SUBJECT: Transmittal of Revised Responses to AP1000 DSER Open Items

AP1000 Design Certification Review
Draft Safety Evaluation Report Open Item Non-Proprietary Responses

DSER Open Item Number: 19.1.10.1-5 (Response Revision 1)

Original RAI Number(s): 720.009, 720.012, 720.013, 720.014, 720.017, 720.021, 720.024, 720.025

Figure A5.3-25

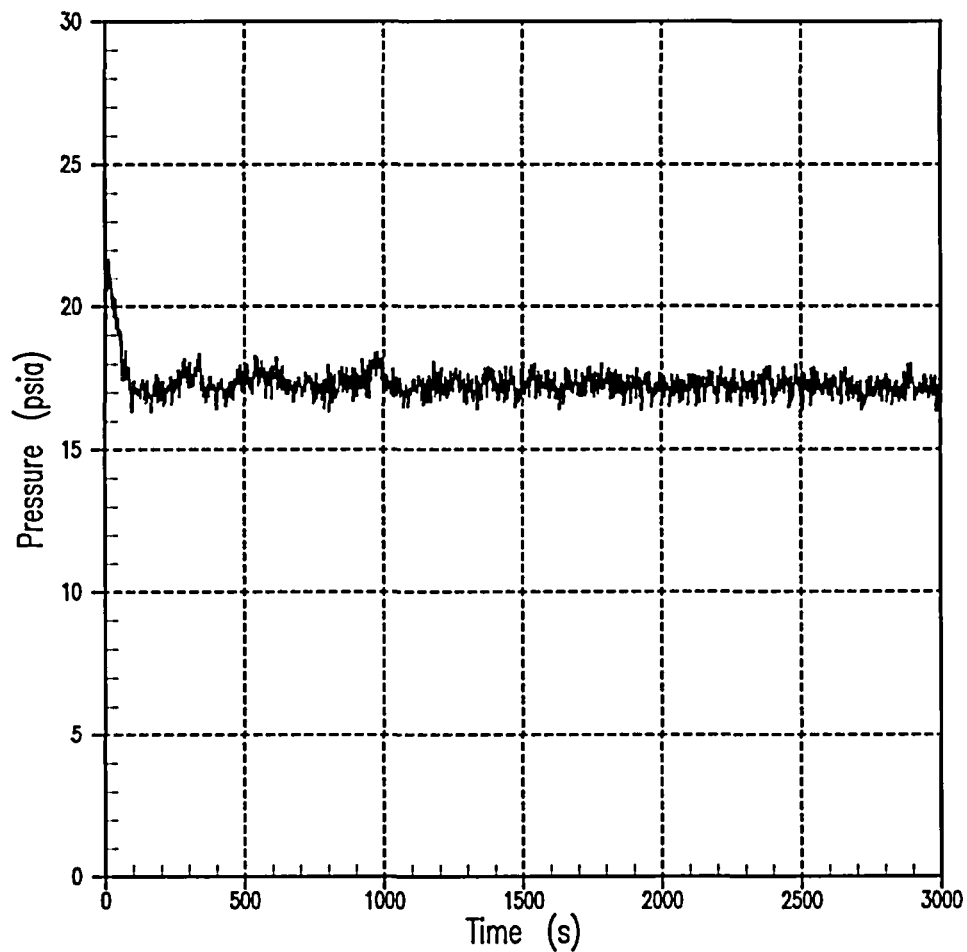
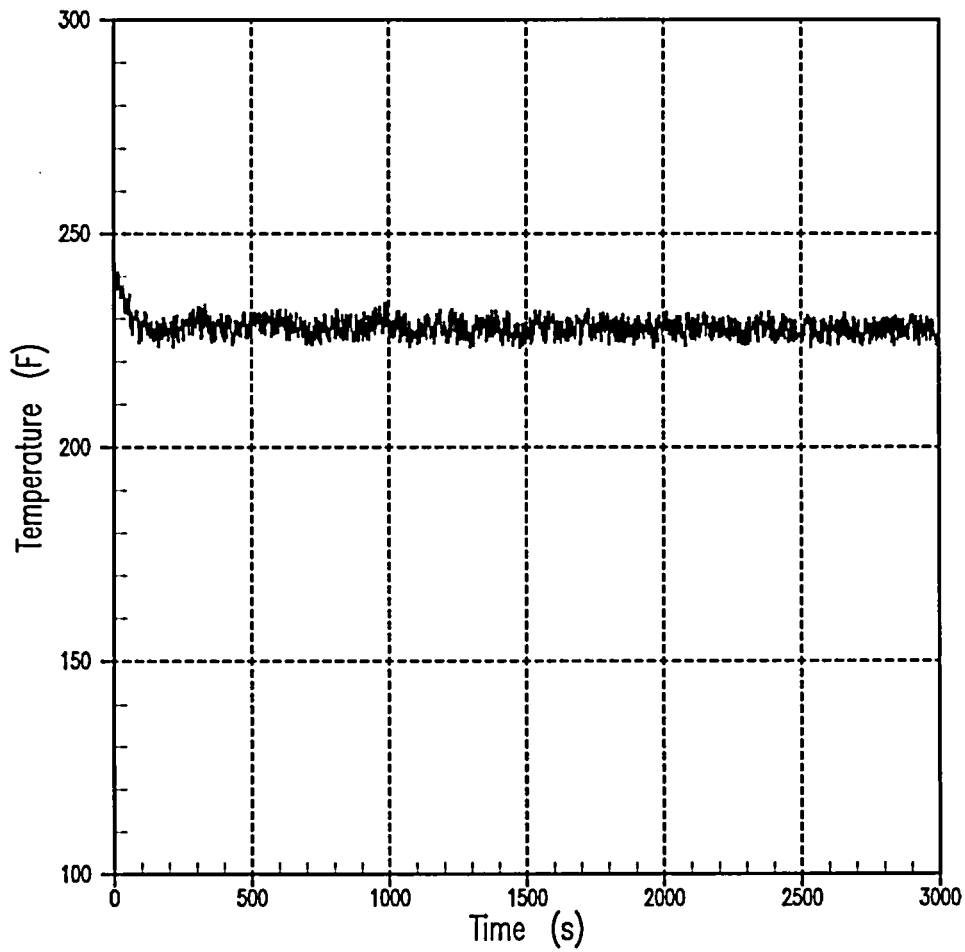
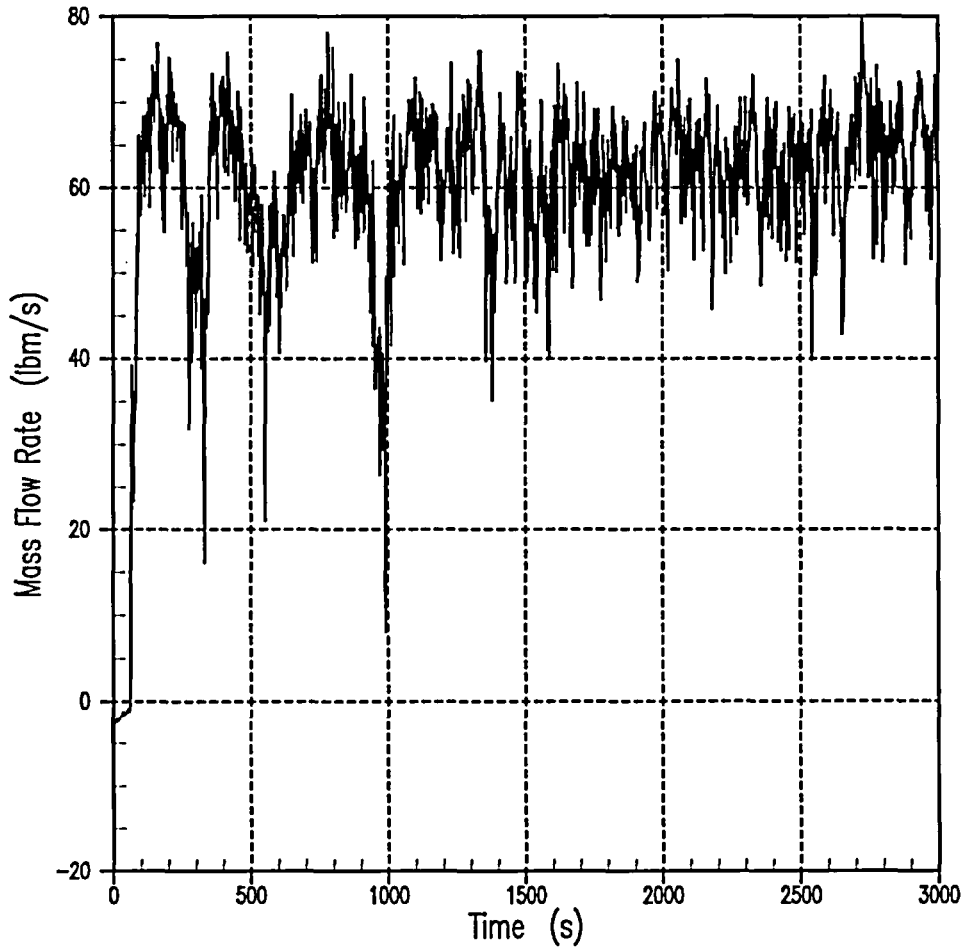
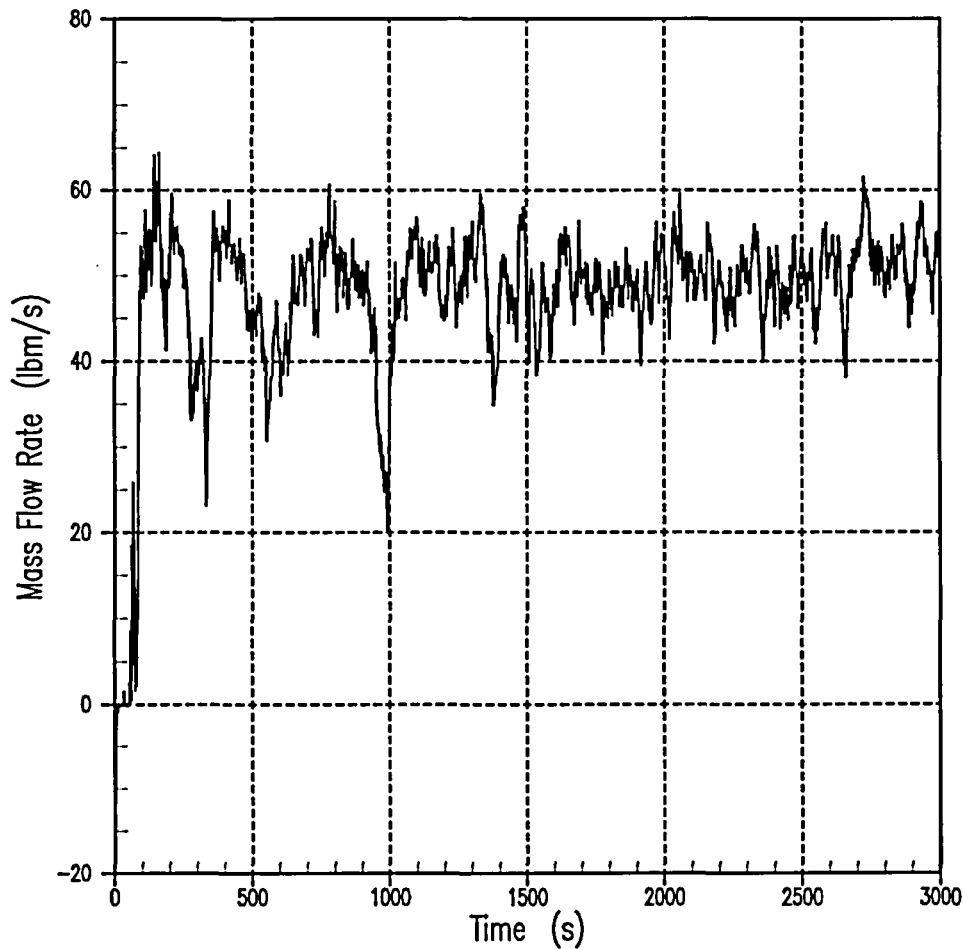
This issue remains open. In the revised response to RAI 720.013, Westinghouse performed long term cooling analyses for bounding conditions in the PRA. (Case F DEDVI, 1 CMT, 1 recirc line, 3/4 ADS4 and CI) and (Case G DEDVI, 1 CMT, 1 recirc line, 4/4 ADS4 and CI failure). The WCOBRA/TRAC code was used for LTC calculations with input conditions derived from MAAP4 analyses. As discussed in the DSER the staff has not reviewed MAAP4 except for its use in screening studies. These are analyses using minimum equipment sets as discussed in the DSER. The staff believes that only a methodology the staff has reviewed should be utilized. In addition, as a result of staff and ACRS questions, the WCOBRA/TRAC long term cooling model has been changed. The staff believes that the revised model should be used in these bounding calculations.

- (a) The long term cooling success criteria analysis case and the thermal hydraulic uncertainty cases F and G have now been performed using the revised WCOBRA/TRAC model and using input conditions from WGOETHIC. The revised cases replace the previous cases as shown below in the revision to PRA Appendix A.

Initially, the only injection comes from the IRWST into the reactor vessel through the intact DVI injection line (Figure A5.3-28). Since at the beginning of the analysis, the level in the PXS-B room is below the DVI injection nozzle elevation, only steam from the downcomer is vented out through the break. Water starts to flow back into the downcomer through the broken DVI line about 2 hours into the transient. This is the time when the level has about reached its minimum value in containment, yet decay heat is still relatively high in the PXS-B room becomes high enough to provide sufficient driving head for this to happen. This time, unlike the Case F DVI break scenario, the transition into reversed injection of water through the break into the downcomer occurs a little earlier, and is somewhat softer. As a result, the increased depressurization rate observed in Case F does not occur. Still, the levels in the downcomer (Figure A5.3-15), the reactor core (Figure A5.3-16) and the upper plenum (Figure A5.3-22) are maintained high enough by the available DVI injection to provide acceptable core cooling.

The availability of all ADS Stage 4 valves provides enough venting capacity to assure adequate depressurization and successful performance of the passive safety systems (Figures A5.3-23 and A5.3-24). The fuel remains covered throughout the transient, and adequate core cooling is provided to remove the decay heat. The hot rod cladding temperature at the top of the core is about 20°F above saturation (Figure A5.3-26) and steadily decreasing.
